CITY OF BEVERLY HILLS
DEPARTMENT OF PUBLIC WORKS
345 N. FOOTHILL ROAD
BEVERLY HILLS, CALIFORNIA 90210

ADDENDUM NO. 1

LIBRARY ADMINISTRATION STAFF OFFICES IMPROVMENTS PROJECT

DATE OF ADDENDUM: JULY 23, 2019

EXHIBIT 'A'

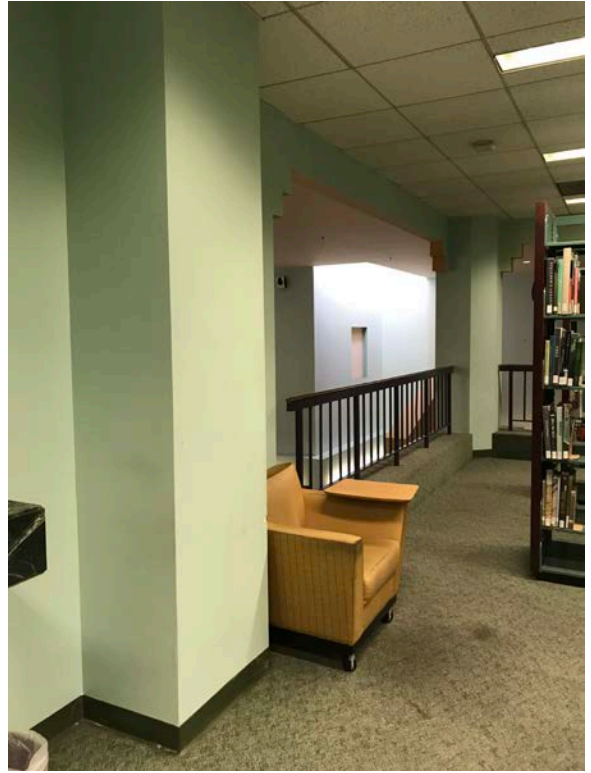
Refer to sheet # A-1.11, Second Level New Construction Plan, northeast area of work [(N) office 213, 215, 217 & (N) Study 214, (N) Waiting Area 216]. Provide Add Alternate Cost for demolition of three (3) existing book shelves and relocation of three (3) existing book shelves. The Base Bid shall consider demolition and relocation by others. See Exhibit ‘A’ for images of existing book shelves.

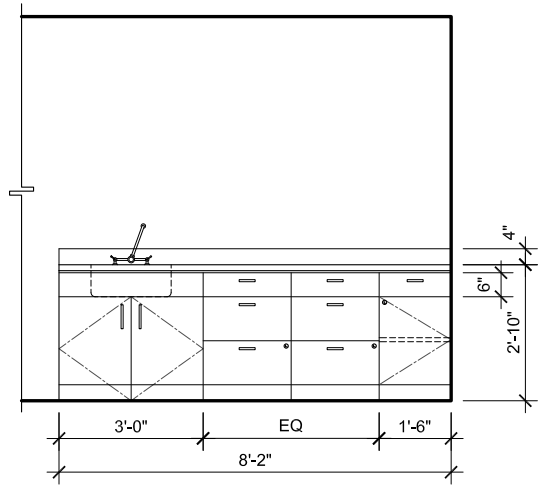
Refer to SK-1 – South Meeting Room Plan has been added and included in this Addendum. Provide an Add Alternate Cost for replacement of (E) Cabinet with (N) Cabinet as shown in plan and elevation. The Base Bid shall consider leaving existing cabinet as is in place.

SK-1
(E) SOUTH MEETING ROOM
SCALE: 1/8" = 1'-0"

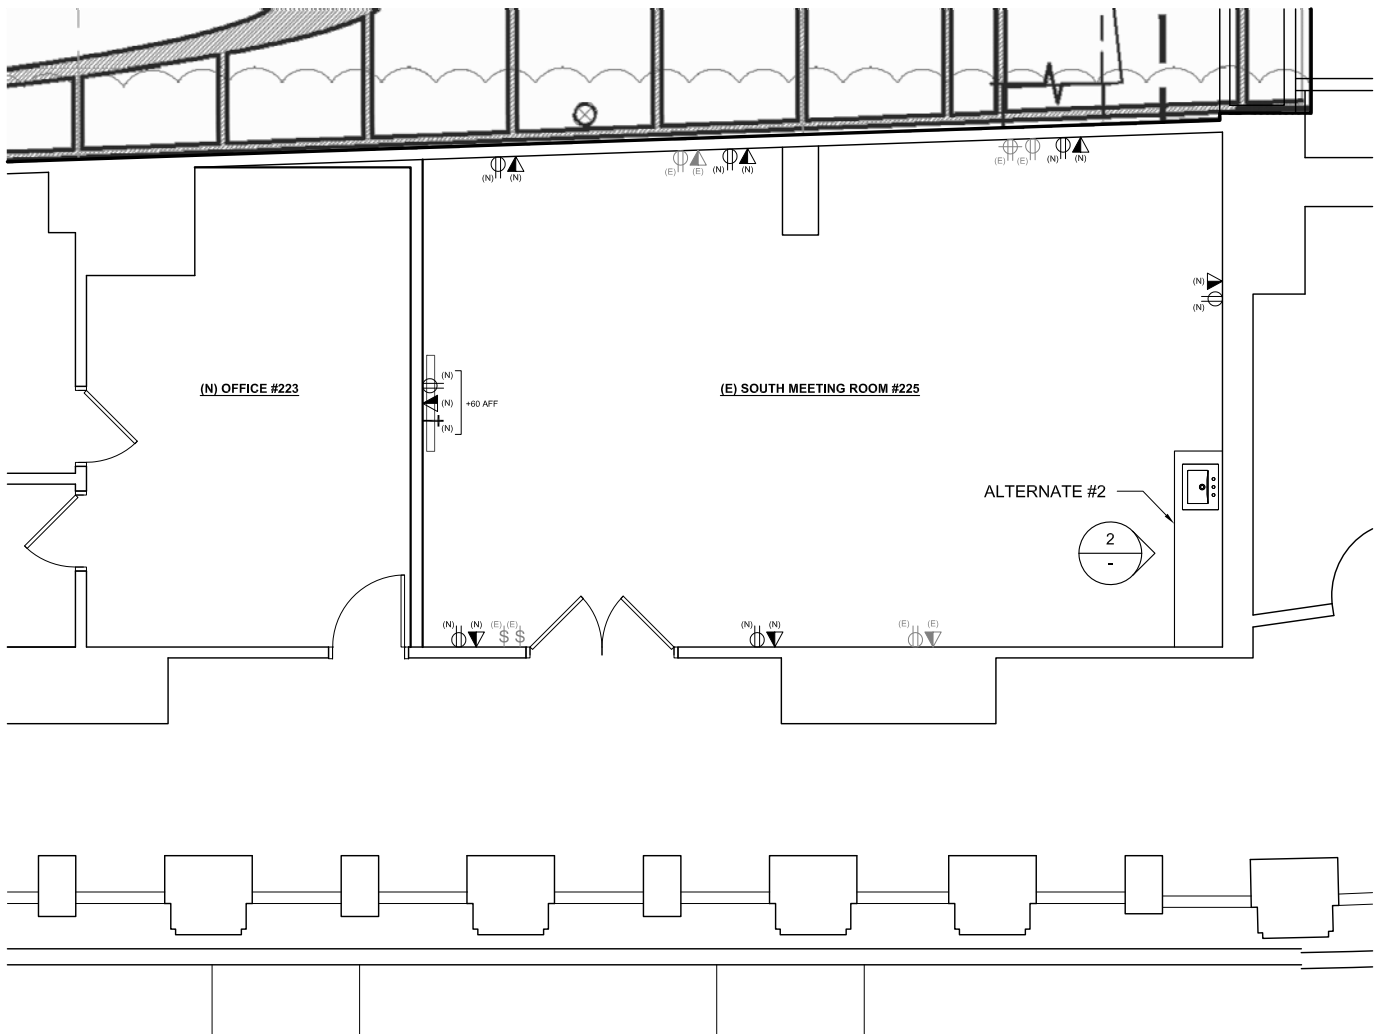
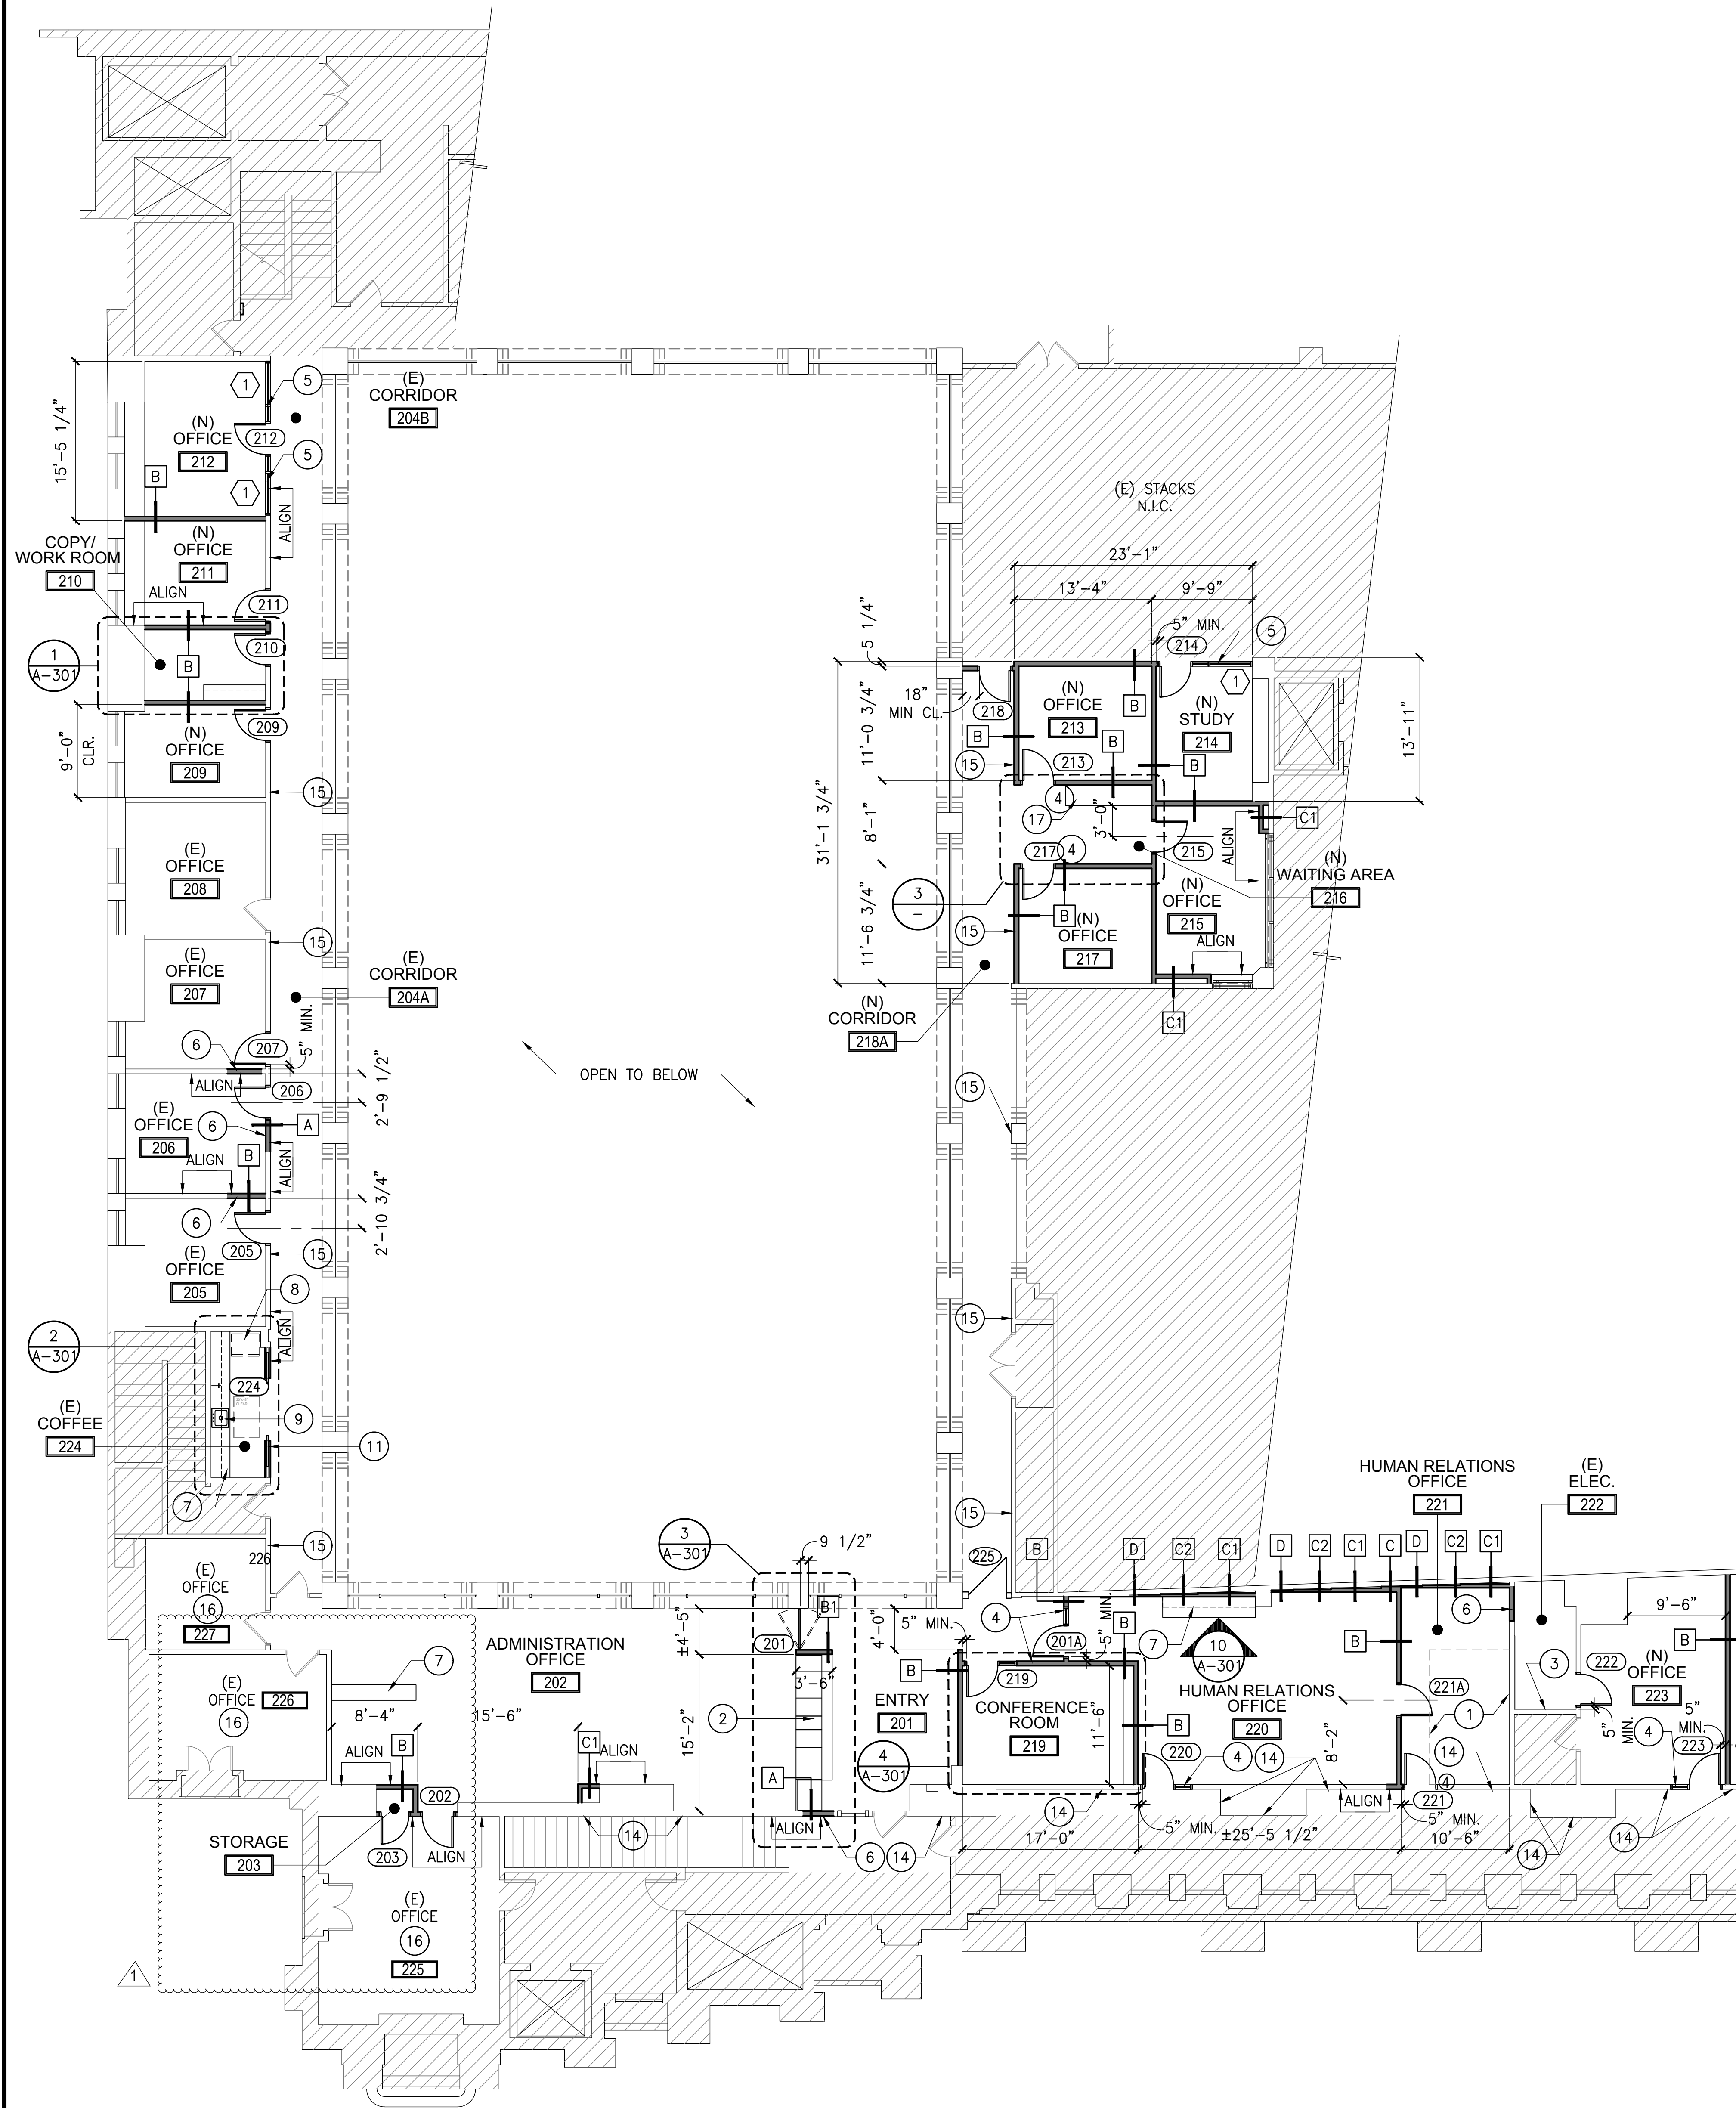
Refer to SK-1 – South Meeting Room Plan has been added and included in this Addendum. Provide an Add Alternate Cost for replacement of (E) Cabinet with (N) Cabinet as shown in plan and elevation. The Base Bid shall consider leaving existing cabinet as is in place.

- 3.1 Refer to SK-1 – South Meeting Room Plan provided in this Addendum No.1. Seven (7) new power and data outlets, plus one (1) cable connection including conduit and back box, shall be provided as shown in plan. Communication outlets shall include back boxes and conduits to terminate at 6” above finish ceiling. Cables and terminations are included in Allowance #2.
